TM 11-5820-401-20

RADIO SETS AN/VRC-12 AND AN/VRC-43, -44, -45, -46, -47, -48, AND -49

TM 11–5820–401–20
CHANGES No. 2

HEADQUARTERS
DEPARTMENT OF THE ARMY
WASHINGTON, D. C., *24 September 1963*

Figure 2. Mounting MT–1029/VRC junction box, cover removed.

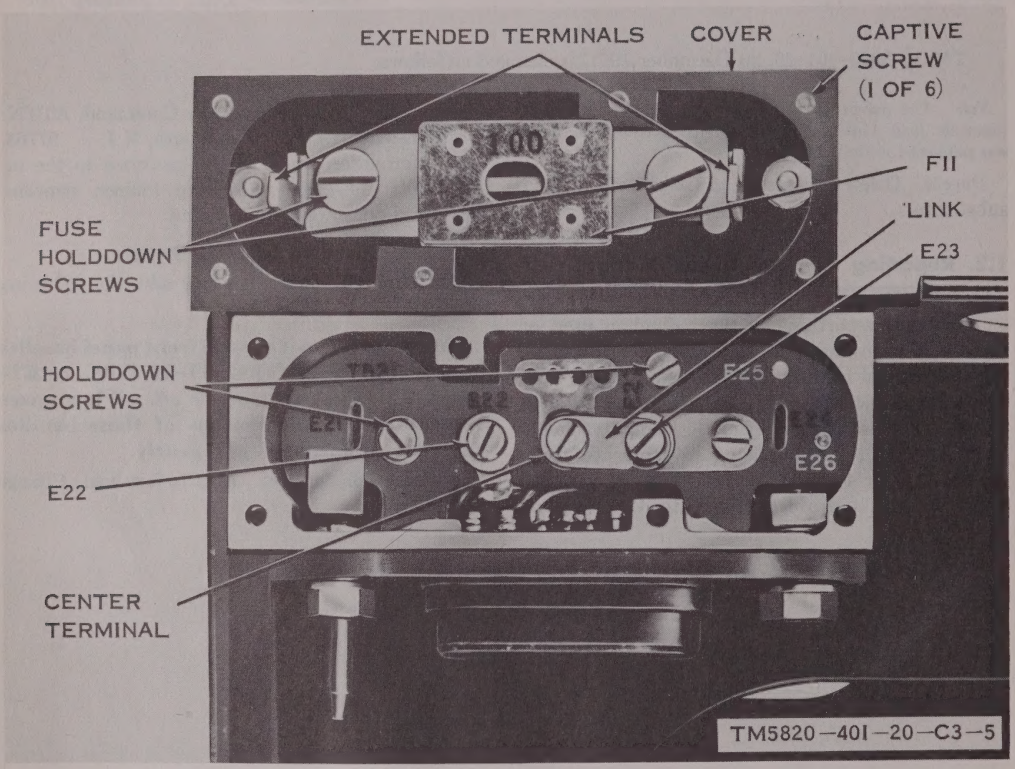
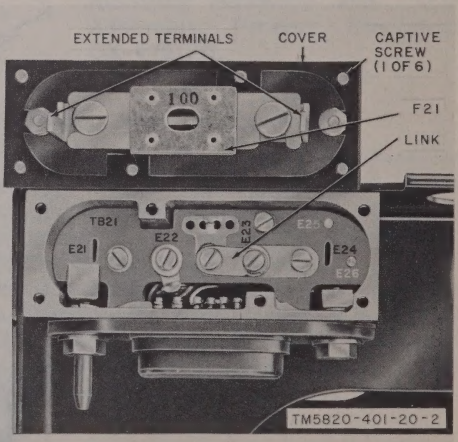
Change "F21" to "F11" in the following places (as changed by C 1, 19 April 1963):

Page 4, paragraph 4*a*(1) (*d*), line 4 and figure 2.

Delete figure 2 and substitute new figure 2.

Figure 3. Mounting MT–1898/VRC junction box, cover removed.

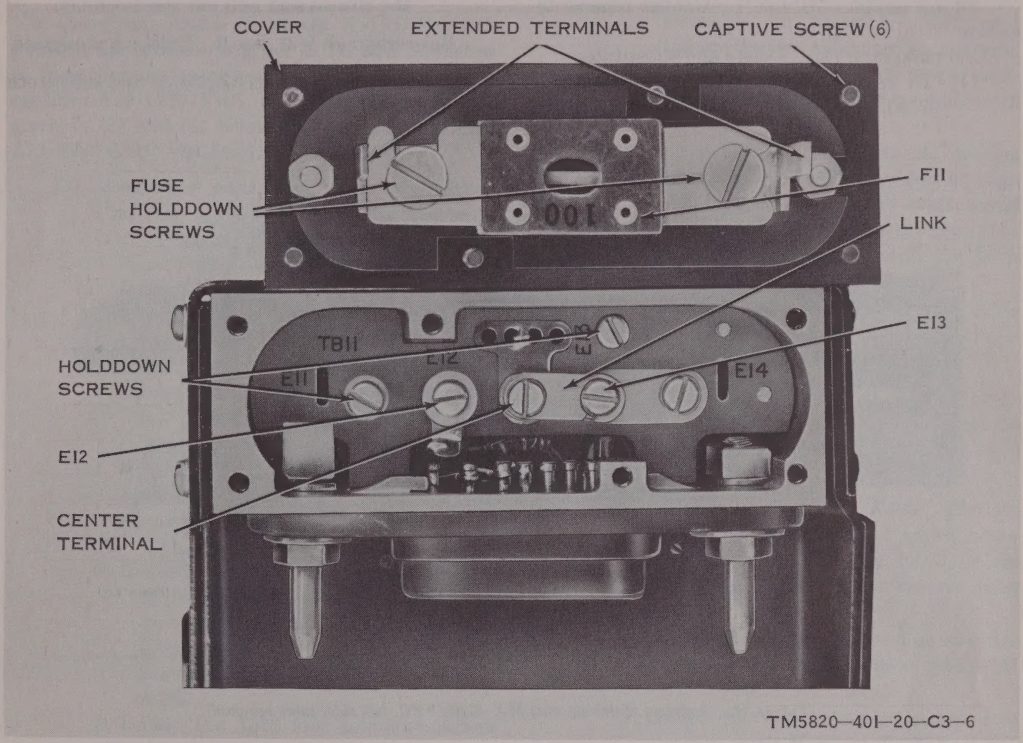
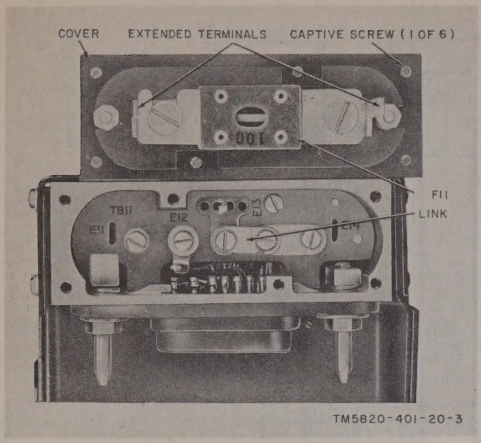
Paragraph 4*a*(2)(*c*). Next to last line. Change E14 to E13.

Page 5. Delete figure 3 and substitute new figure 3.

Figure 32. Antenna matching unit MX-2799/VRC, left side, cover removed.

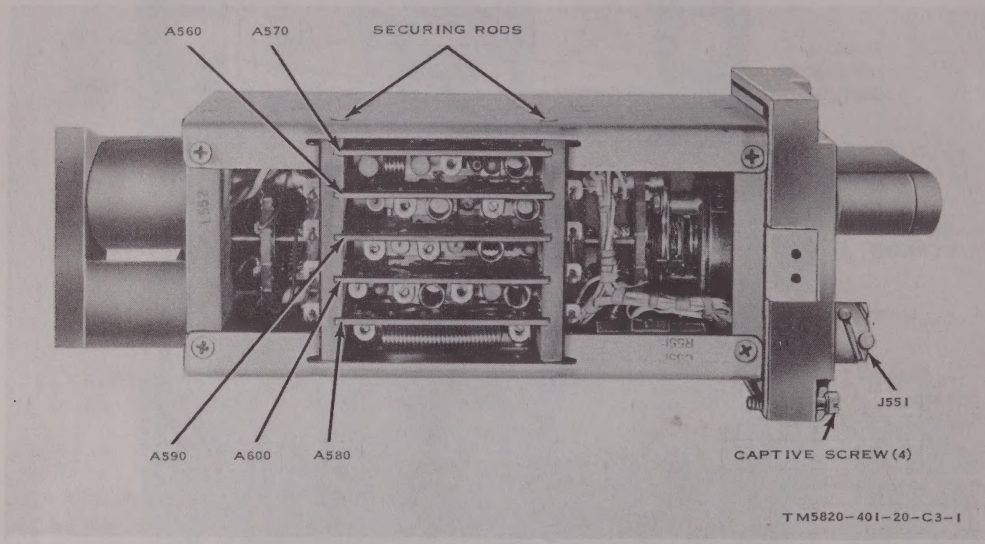
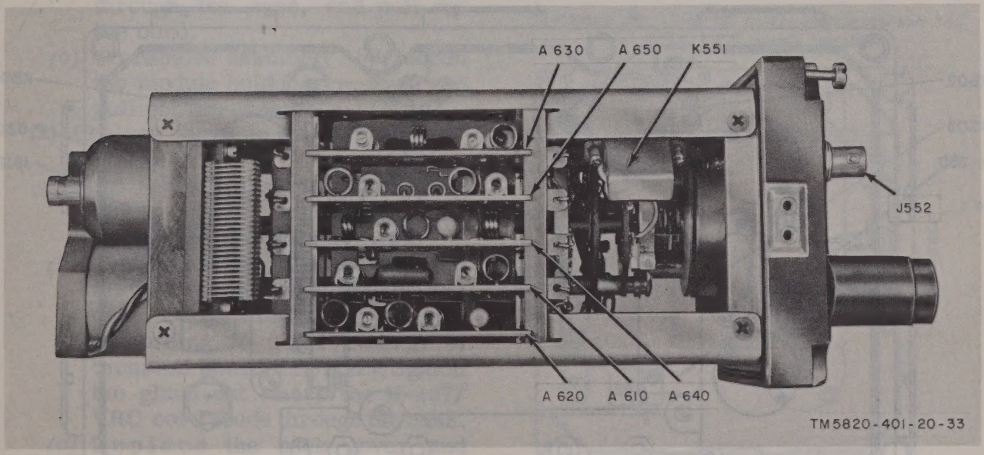
Page 61. Delete figures 32 and 33 and substitute new figures 32 and 33.

(4) To remove assembly A560, A570, A580, A590, or A600 (fig. 32) or assembly A610, A620, A630, A640, or A650 (fig. 33), pull the two securing rods straight up out of the chassis and pull out the assembly.

Figure 34. Amplifier, audio frequency AM-1780/VRC (manufacturer-modified), back cover removed.

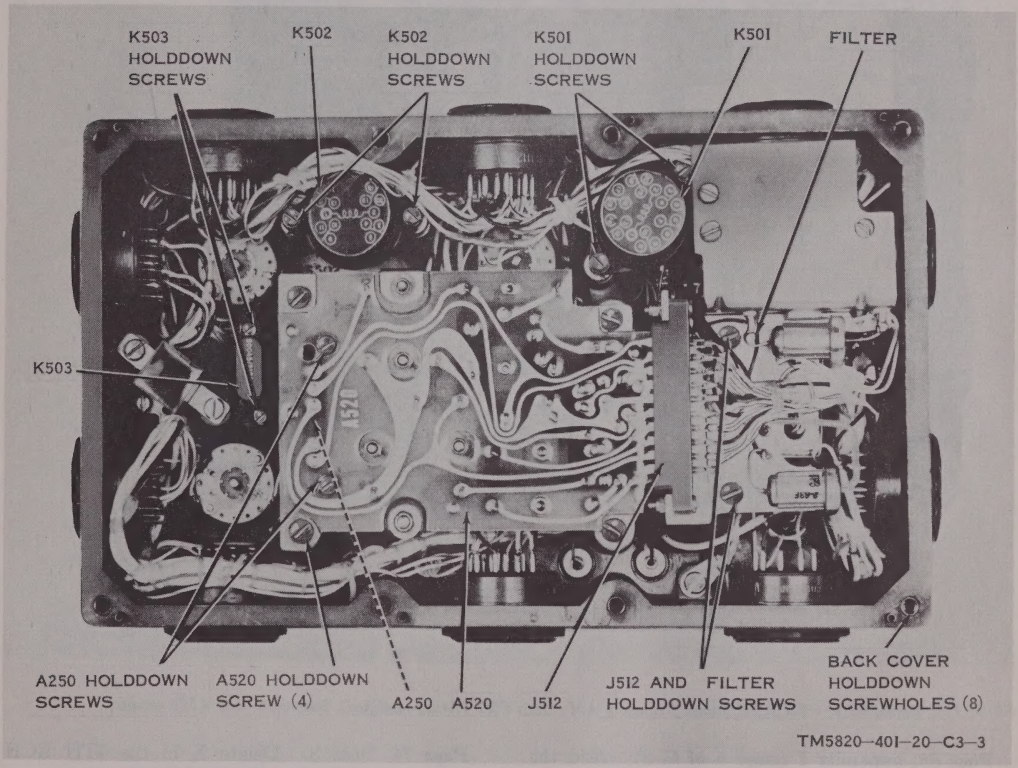
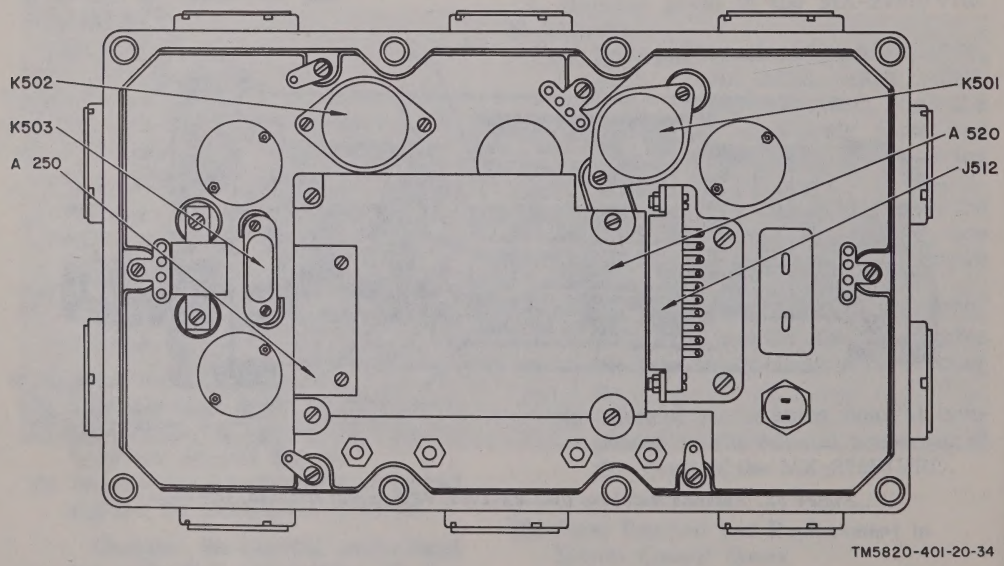
Delete figure 34 and substitute new figure 34.

a. Amplifier, Audio Frequency AM–1780/VRC. Perform the procedures given in (1) and (2) below to remove and replace parts in the manufacturer-modified AM–1780/VRC (fig. 34) or the procedures given in (3) and (4) below for the Army-modified AM–1780/VRC (fig. 34.1).

Figure 34.1. Amplifier, audio frequency AM–1780/VRC (Army-modified), back cover and A520 removed.

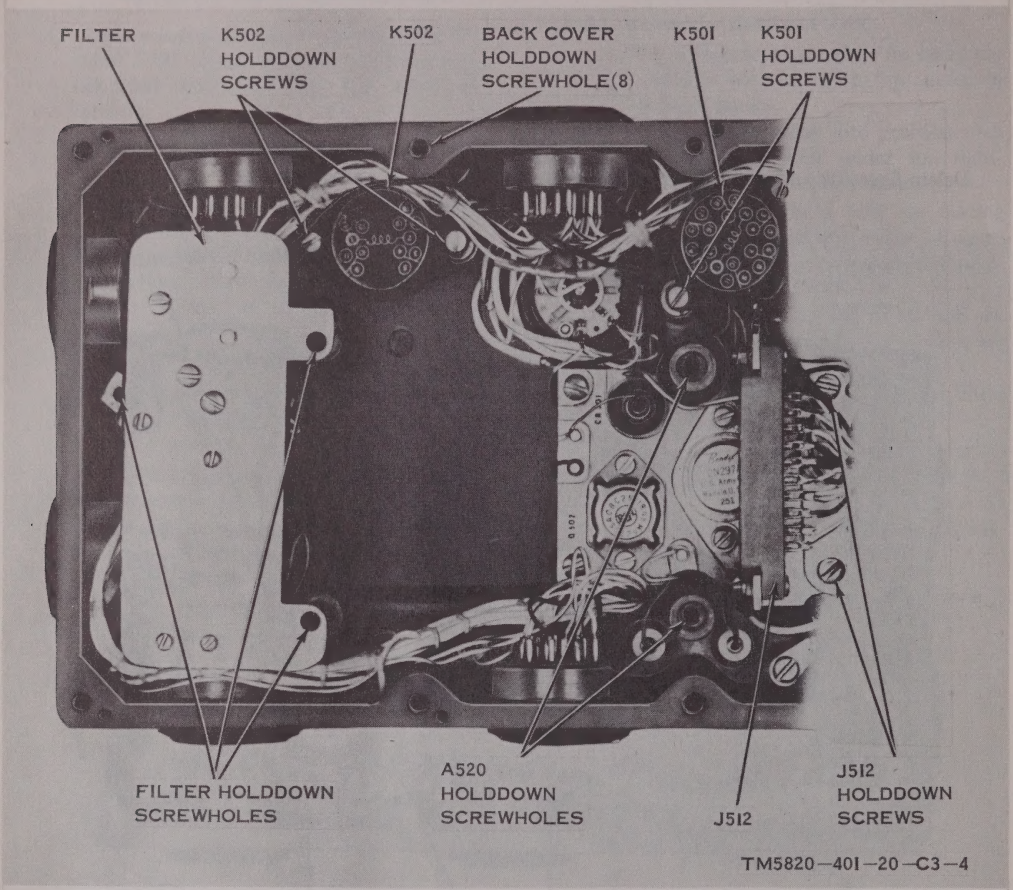
Add figure 34.1 after figure 34.
